APPLICATION FOR A CERTIFICATE OF APPROPRIATENESS – STAFF REPORT

003-18-CA 917 W SOUTH STREET

Applicant: JOHN AND CARLEN DEMLER

<u>Nature of Project</u>: Remove rear deck and screened porch; construct rear addition; construct side deck; replace window with sliding doors; remove tree; remove fence

Tree Protection

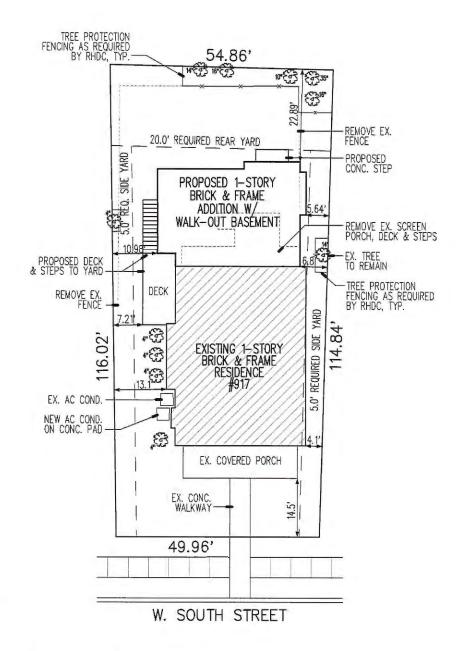
- 11* A replacement mature crape myrtle tree is proposed for the southeast corner of the lot.
- 12* A tree protection plan was provided; however, the critical root zones may not be sufficiently protected with the plan. The critical root zone is defined as "The area uniformly encompassed by a circle with a radius equal to one and one-quarter (1.25) foot per inch of the diameter of a tree trunk measured at four and one-half (4.5) feet above the ground, with the trunk of the tree at the center of the circle."

- 13* Staging areas for construction materials were not specified on the tree protection plan.
- C. Replacing a window with a door is not incongruous according to *Guideline* 2.7.9; however, replacing a window with a **sliding** wood-frame door **may be** incongruous according to *Guideline* 2.7.9, and the following suggested facts:

- 1. That tree protection plans be implemented and remain in place for the duration of construction.
- 2. That there be no demolition delay for the removal of the tree.
- 3. That the sliding wood-framed door proposed for the east elevation be changed to paired French-style doors.
- 4. That details and specifications for the following be provided to and approved by staff prior to issuance of the blue placard:
 - a. A tree protection plan that addresses the critical root zones and provides staging areas for construction materials.

CUSTOM WOOD WOOD PATIO DOOR SLIDING PATIO DOOR

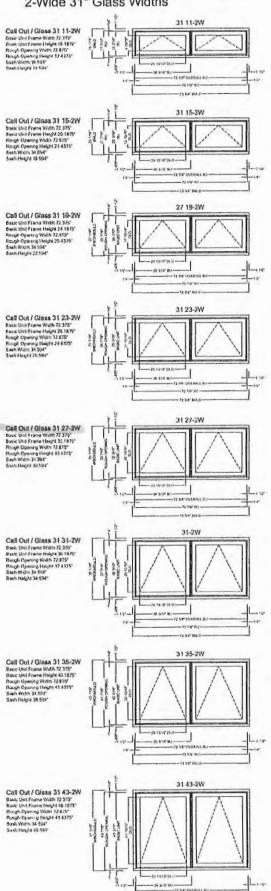
- 1* The only existing window proposed for removal on the east elevation is proposed to be replaced with a Jeld-Wen sliding wood-frame door with simulated divided lights. Sliding doors are not characteristic of the historic district.

- 2* This alteration may be partially visible from the public right-of-way, although the new sliding door would be partially obscured by mature vegetation.
